1 **RESPONSES TO ONTARIO ENERGY BOARD STAFF**
2 **INTERROGATORIES**

3
4 **INTERROGATORY 2-STAFF-3**

5
6 Residential power allocation standards

Fig 1: 80th Percentile Customer Loading Profile with 73.5% EV Penetration

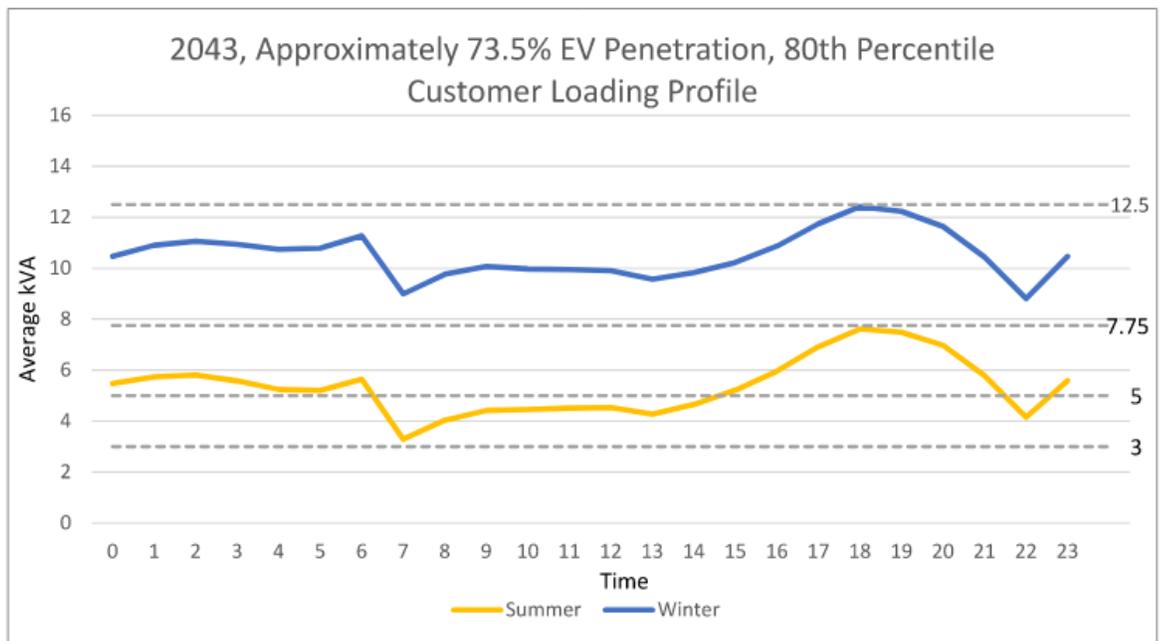
30 (a) Please describe how Entegrus Powerlines determined that 6 kVA and an optional
31 12 kVA were the appropriate residential capacity allocations (specifically and as
32 opposed to any other allocation amount), and 100 kVA the appropriate transformer size?

- 18 a) This strategy is fully aligned with broader policy context: the Federal government’s
19 decarbonization policy targets 100% zero-emission light-duty vehicle sales by 2035¹. At the
20 provincial level, the IESO forecasts that Ontario’s electricity demand will grow by 75% by
21 2050². Using the growth assumptions in these documents, additional public information
22 (such as average number of vehicles per home, and average vehicle age), technical
23 specifications for common L2 EV chargers, historical smart meter data and climate trend
24 data EPI analyzed its loading data for residential customers and modelled future
25 electrification load profiles incorporating the higher usage added by EV and electric heat
26 pump adoptions. The analysis modelled 80th and 90th percentile residential loads beyond

1 2060. Results showed that winter will become the new system peak, and the average 80th
 2 percentile customer load may reach 12.5 KVA as early as 2043. Given this forecast, the
 3 incremental loads were not expected to finish materializing until mid-way through the life of
 4 a transformer installed today. Due to the uncertainty of forecasts over this time period, EPI
 5 adopted a staged approach. The initial deployment of 6.25 KVA per household aligns with
 6 current and near-term loading conditions, while 12.5 kVA serves as the long-term
 7 electrification demand load supported by the modelling. This modeling did not consider the
 8 impact of ULON rates, which may concentrate EV loads, accelerating the peak demand on
 9 distribution transformers. The following graph from EPI’s study shows the 80th percentile
 10 customer loading profile with 73.5% electric vehicle penetration in residential households

11 over the next two decades:
